DISHDRAWERS

DD602 Micro-switch Failure – NZ, AUS, SGP, UK, USA

DW030

April 2002

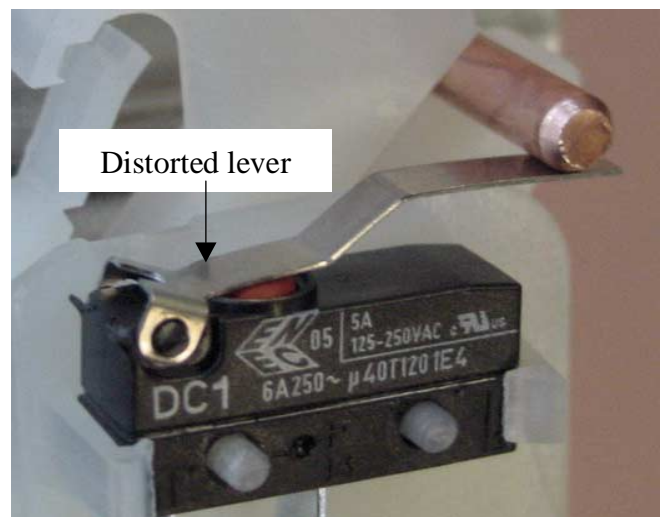
We are seeing a large number of microswitch failures in the field. The main reason switches are failing is because they were damaged during the product's assembly. The slide pin has got under the microswitch lever spring, probably as the slide was being fitted to the product. When the slide was then extended to fit the tub, the lever spring is bent back and damaged. Everything still works the same as the slide pin still activates the microswitch when the drawer is closed. However the life of the spring is reduced from approximately 50,000 operations to approximately 1000 (depending on the extent of the damage.)

When replacing a broken microswitch, it is important to check that the slide pin cannot get under the microswitch lever spring and damage the new part.

Also, for a double DishDrawer, it is essential to check the microswitch in the other drawer to ensure that it hasn't also been damaged. The picture on the left shows a good microswitch, the one on the right shows a damaged microswitch.

Moulded Tub Roller Assembly – Improved Design - NZ, AUS, SGP

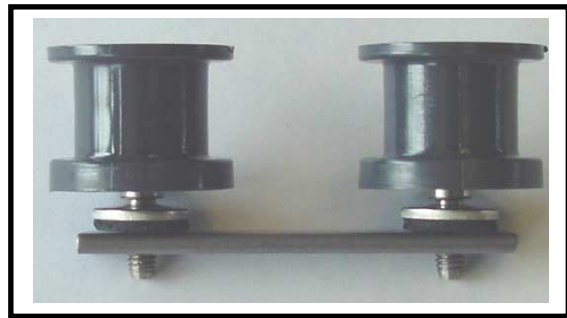
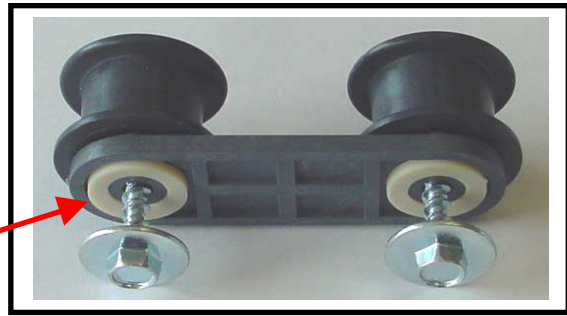
The old design of tub roller is shown below with the tapping plate and screws.

The new design of tub roller is shown below and is available in a spare part kit part number 521428.

Note: The older tapping plates and screws are no longer available for the old tub roller assembly, the old part numbers have been superseded to the part number of the new kit. When ordering parts it is important to only use the part number of the new kit. For example if you ordered a screw and tapping plate from the old assembly you would be supplied with two of the new kits.

Please order and fit the new spare part kit, part number 521428, if there is any sign of stripping or damage to the tub roller assembly or if there has been a repeat call for leaking tub rollers on the product being serviced.

Note: Please check the white seal is correctly fitted before installing the rollers in the product.
The new kit, part number **521428**, includes:

To fit the new design of tub roller, first remove the cabinet wrapper. This must be done because the screws on the new assembly tap directly into the tub rollers from the outside of the tub. Tighten the screws until they are firm. The large head on the new screws gives adequate support to clamp the rollers to the tub. After fitting the new design of tub roller you will notice that the tapping plate is no longer required.
